ADDENDUM NO. 2:

Date: February 6, 2026

Project: Verbena HS Gym
DCM# 2025629
WSM# 25-032

Owner: Chilton County Board of Education
Architect: Ward Scott Morris Architecture, Inc.

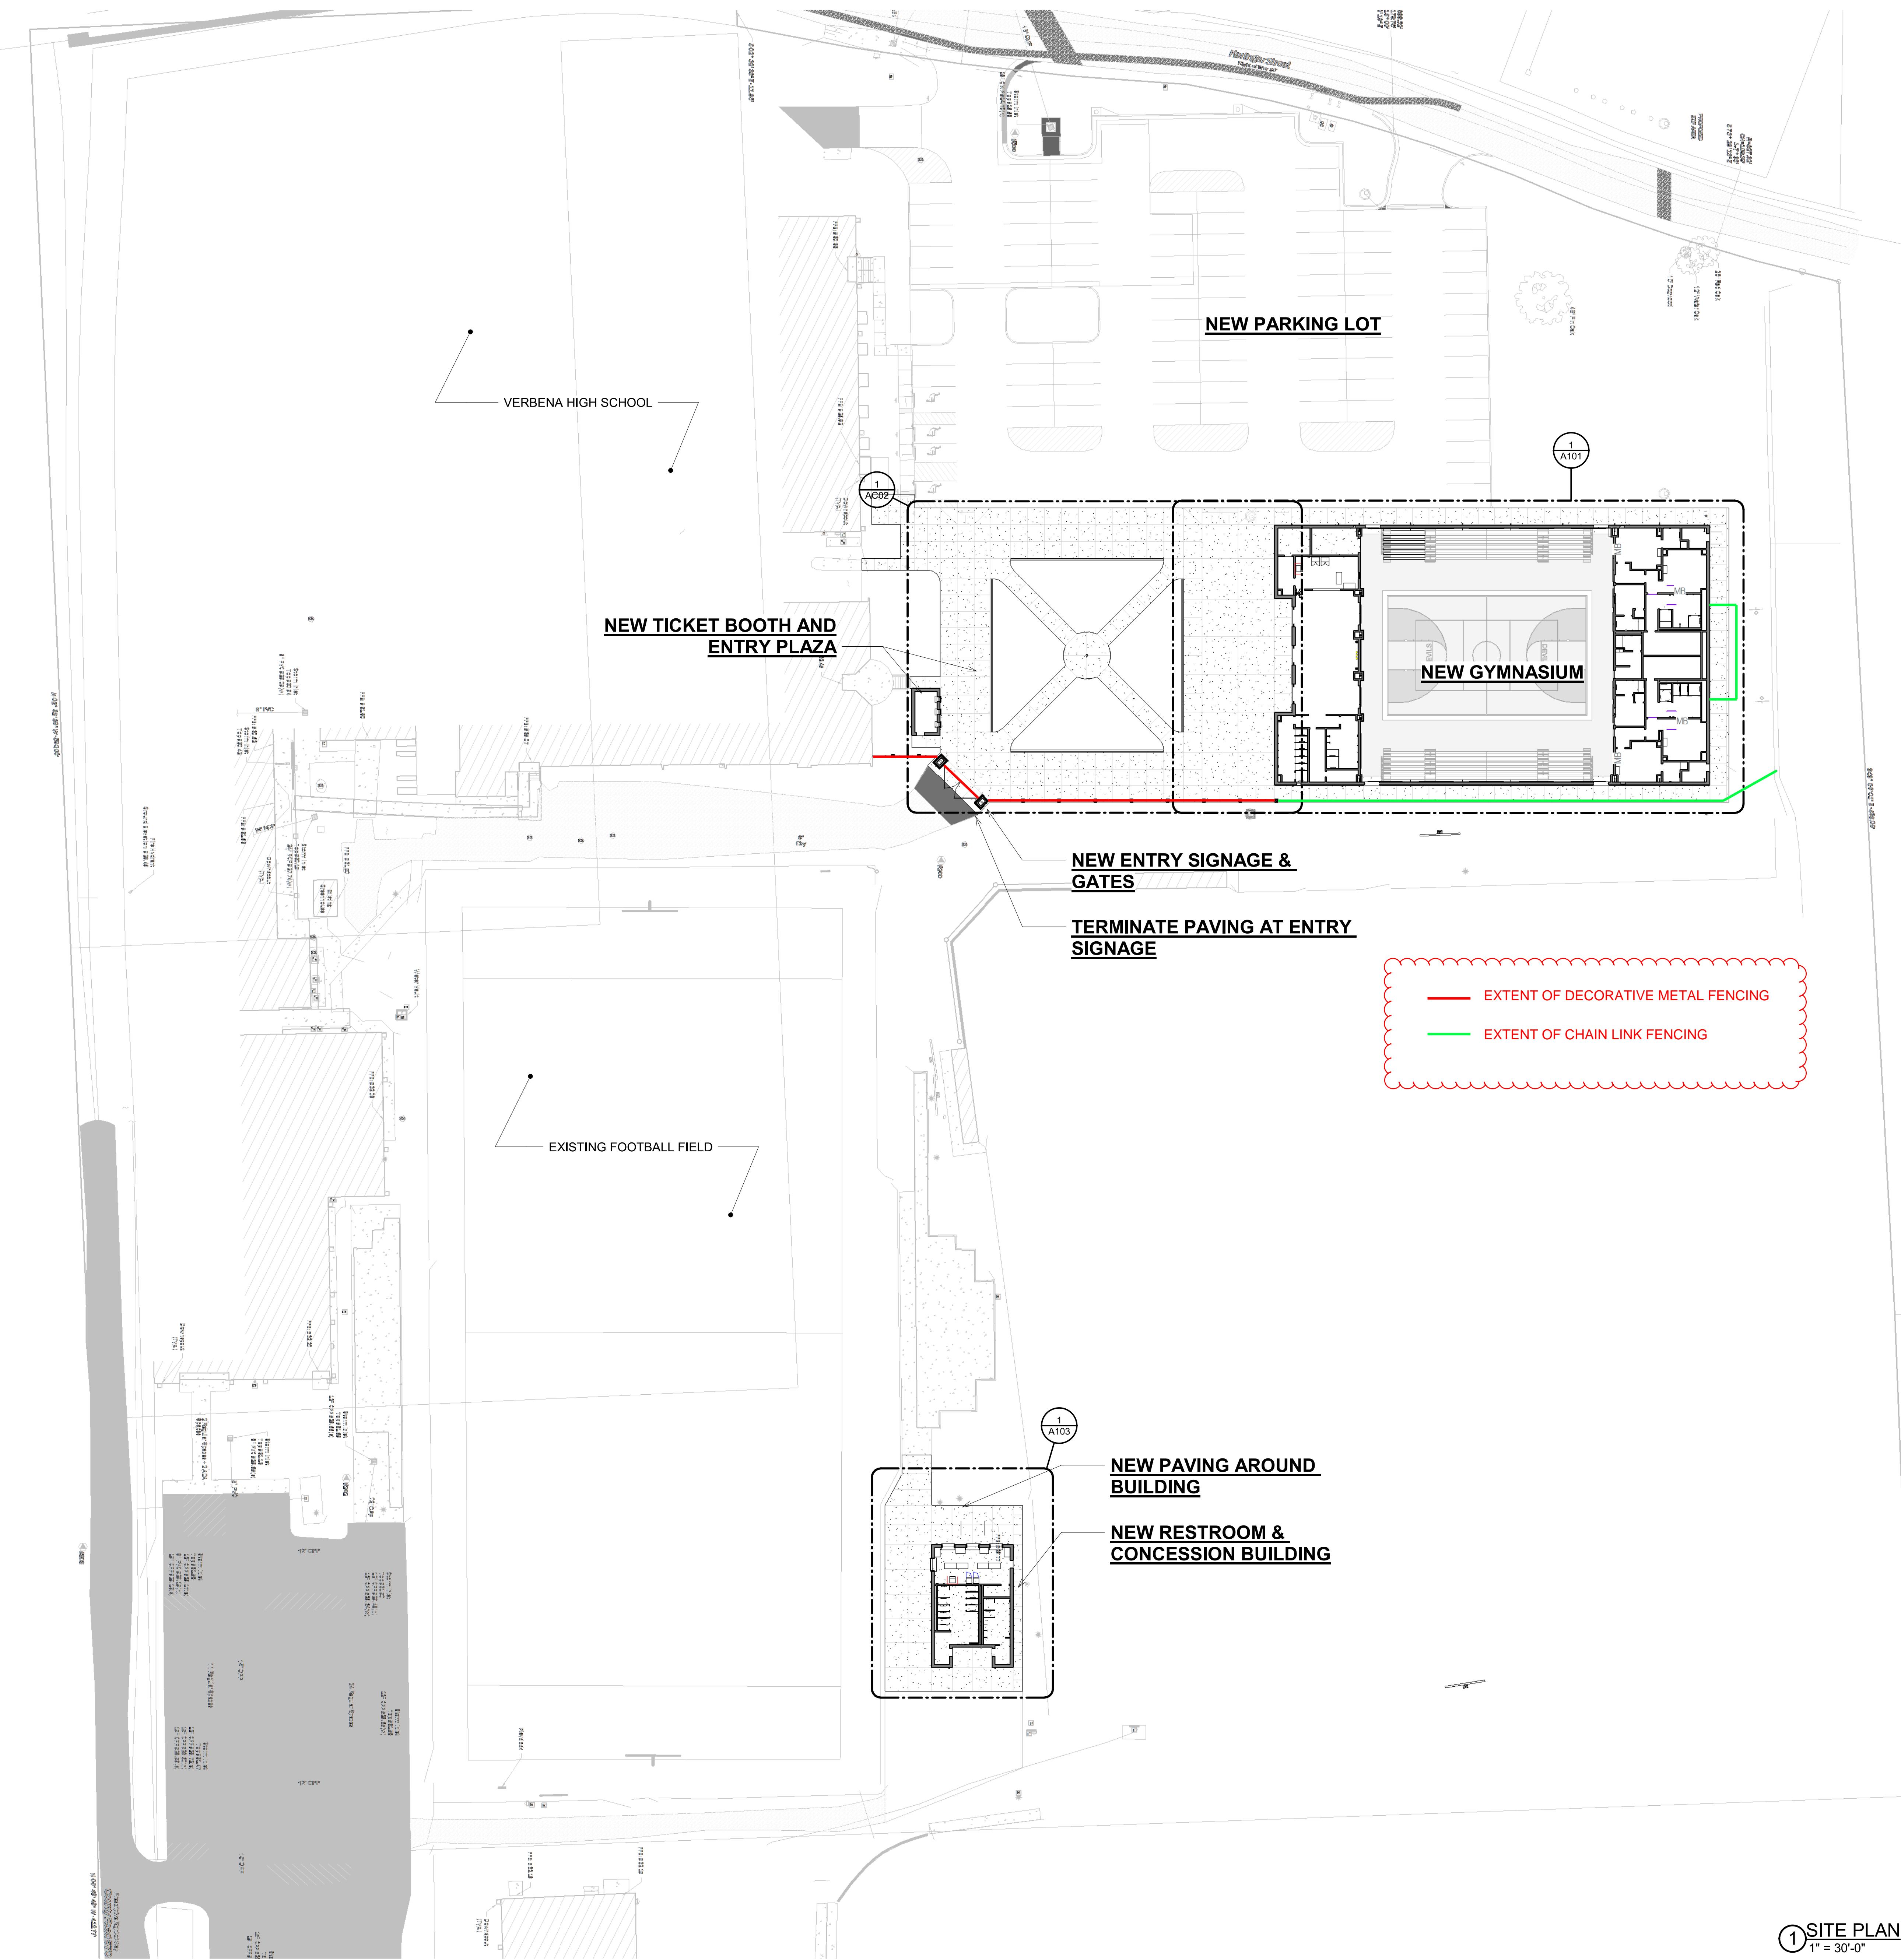
- A. S001; delete joist and joist girder notes as indicated on attached drawing.
- B. S001; Strip and Strip Footing Schedules; estimated quantities have been deleted.
- C. AC01, Extent of fence types clarification. Refer to Addendum No. 1 for extent of mechanical pad fencing.
- D. A301; clarification; east wall of gym along column line #8 to receive drywall on gym side similar to 3/A311.
- E. P201; Pressure Plan; change scale on both 1 and 2/P201 plans to 1/8" in lieu of 1/4".
- F. Electrical Sheets E002, E100, E101, E300, refer to attached addendum 2 on Smith Stegall & Assoc. letterhead and attached drawings.

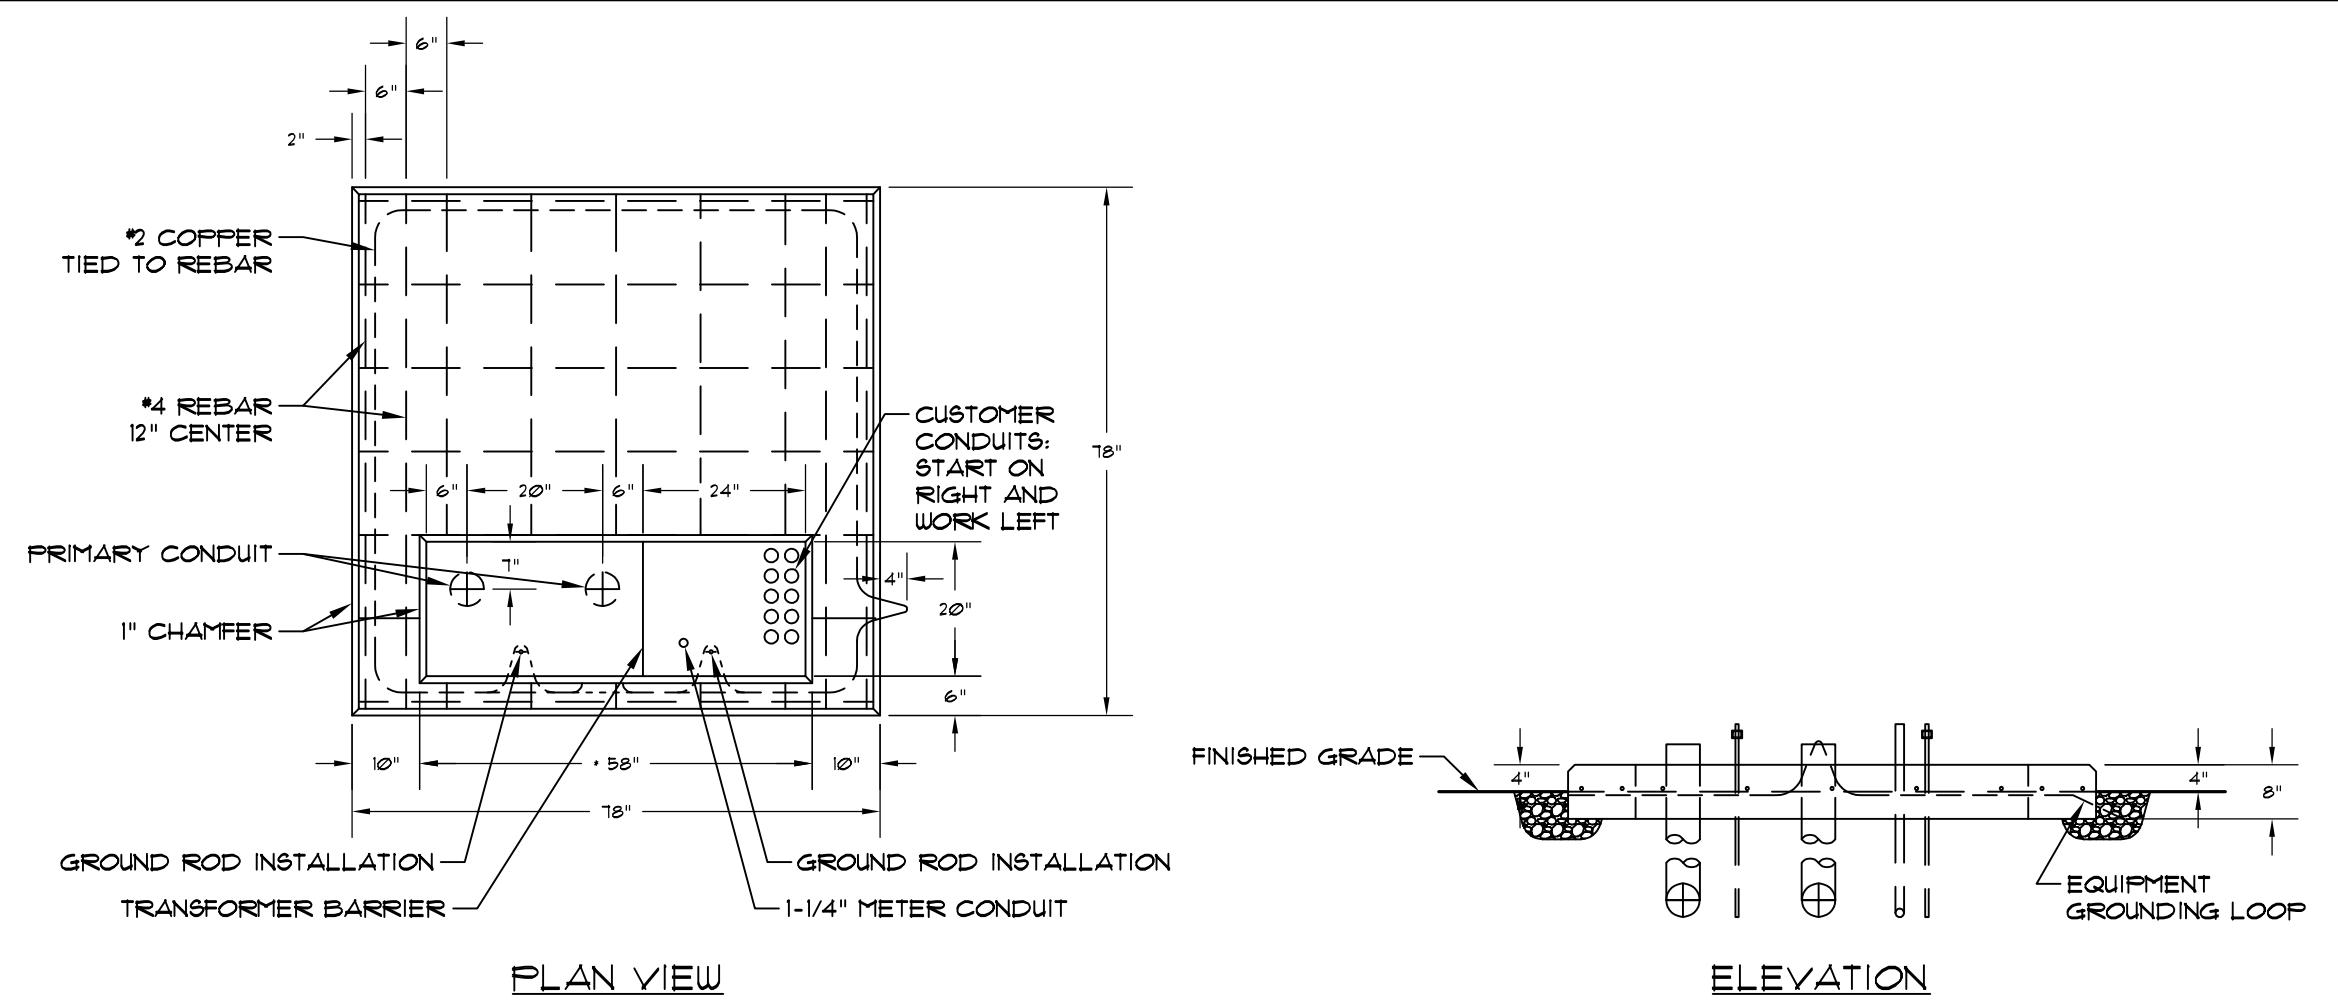
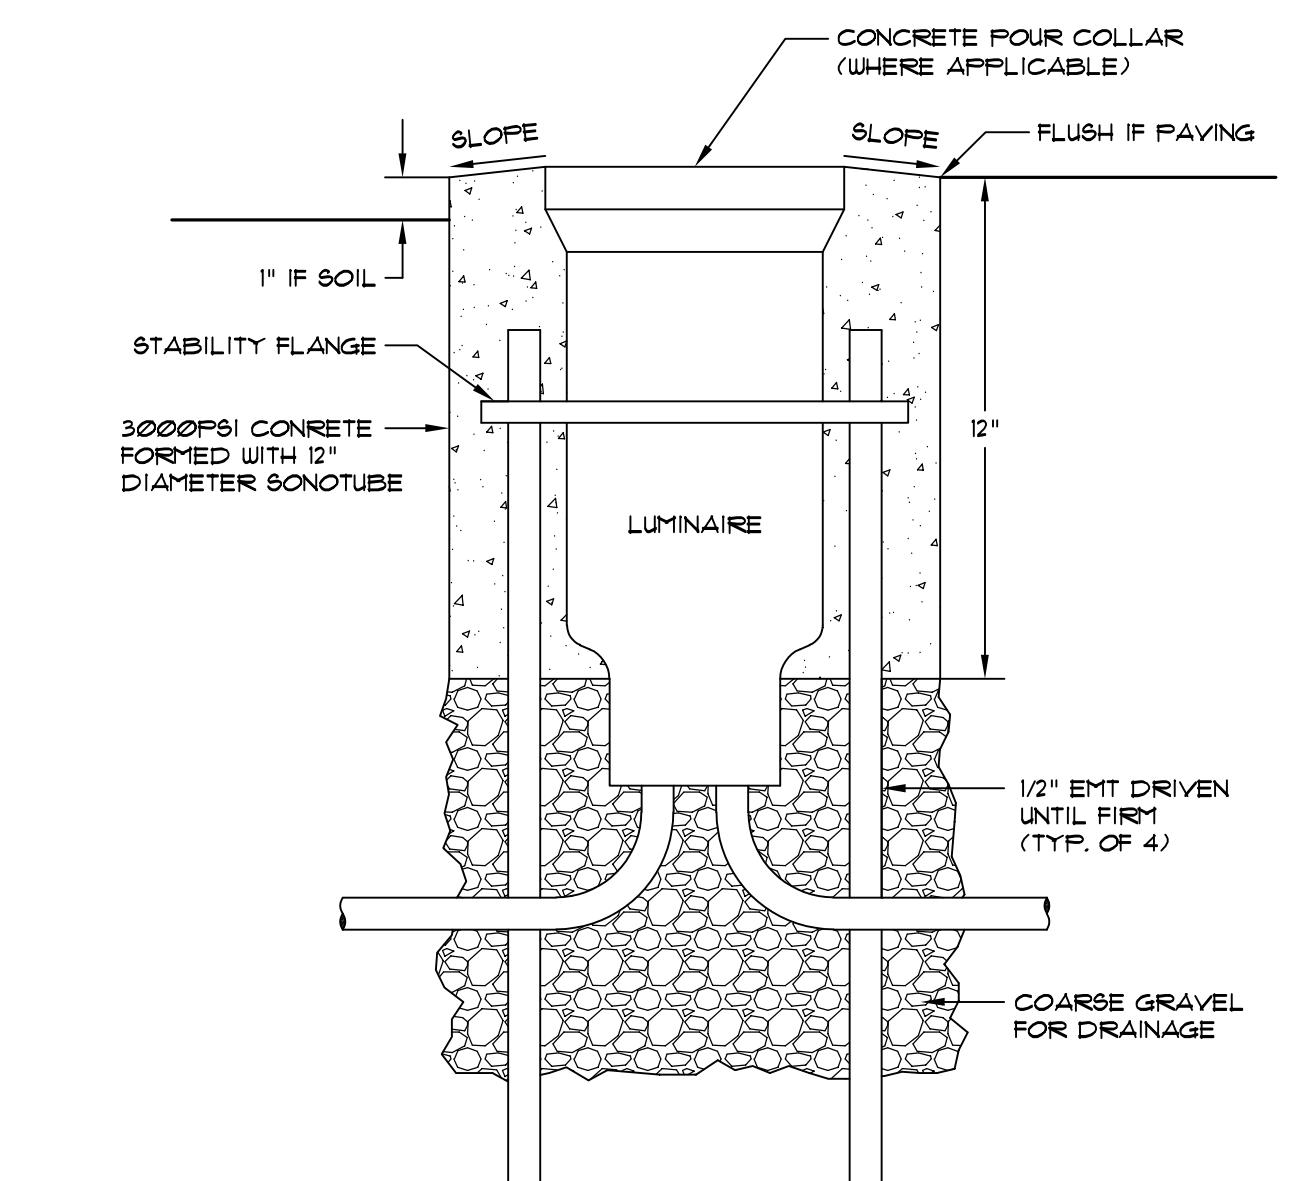
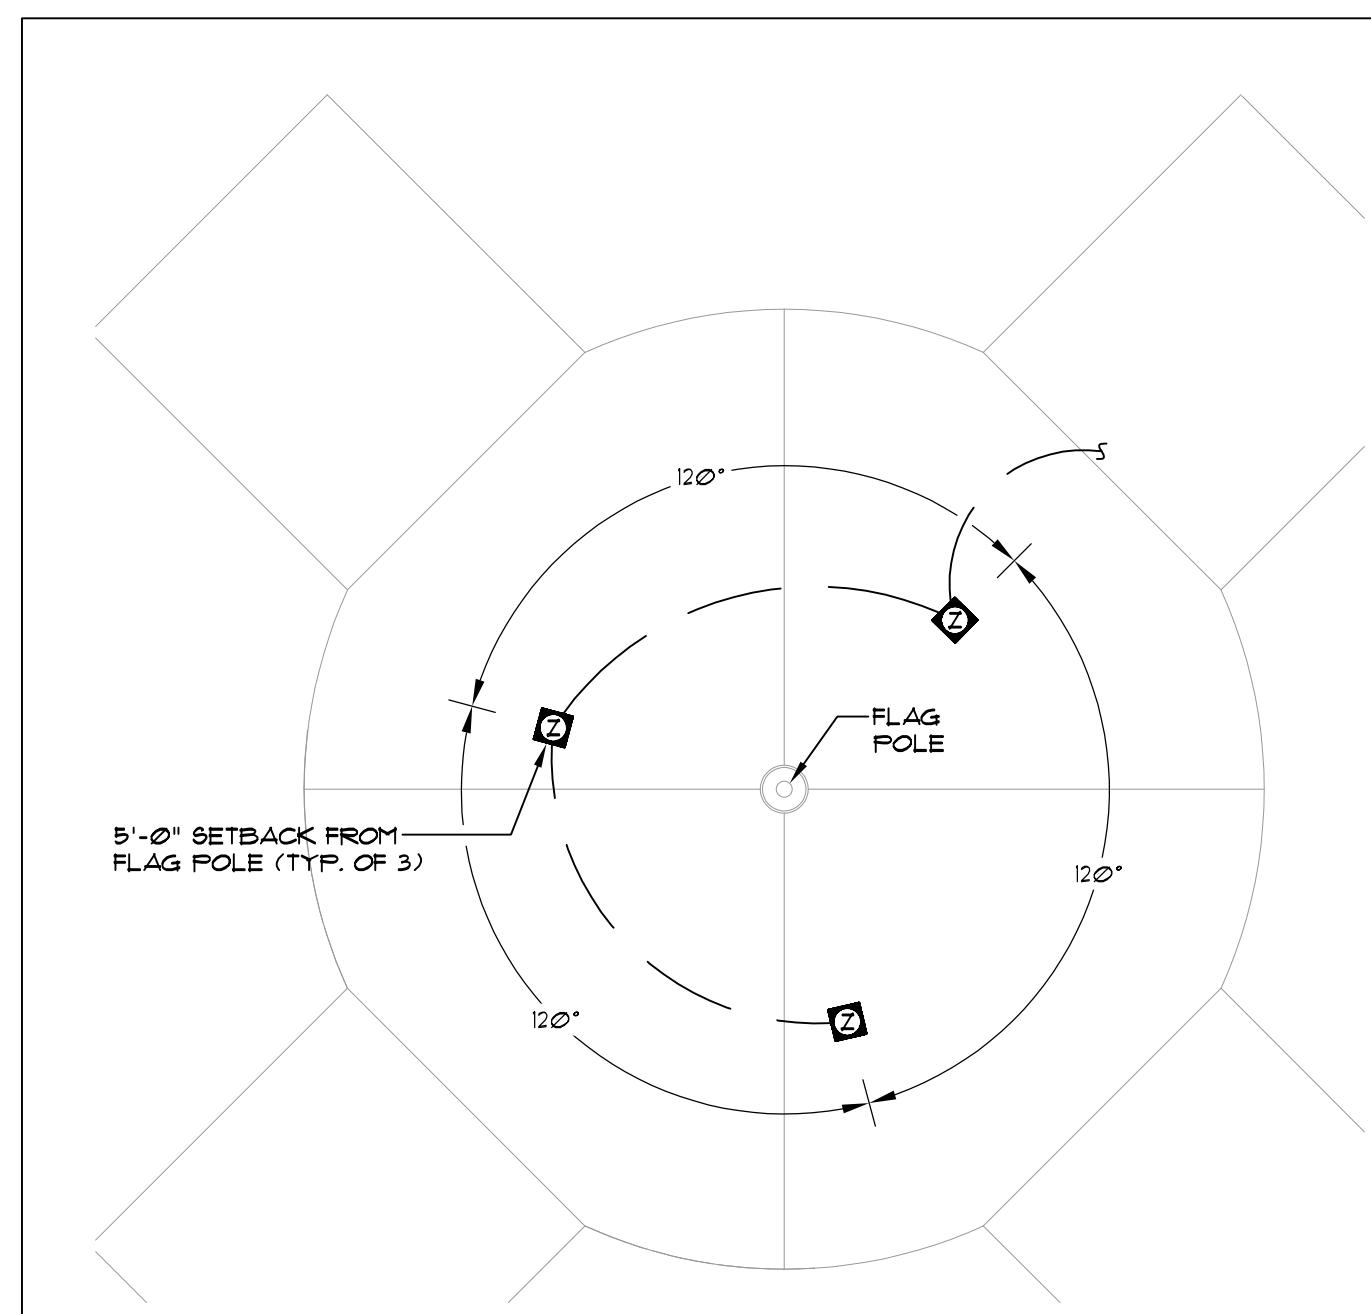
1. **Sheet E002:** See attached sheet for clouded revisions
2. **Sheet E100, Site Electrical Plan:** See attached sheet for clouded revisions
3. **Sheet E101, Gymnasium – Power Wiring Plan, Storage 1105:** See attached sheet. Power added to overhead door.
4. **Sheet E300:**
 - a. **General Auxiliary Notes:** See attached sheet. Notes regarding BDA system bid procedures modified to match specification sections 012200 (Unit Prices) and 012100 (Allowances)
 - b. **Auxiliary Riser Diagram:** See attached sheet. Fiber type revised from OM1 to OM3. Fiber from existing building now shown to be plenum rated.
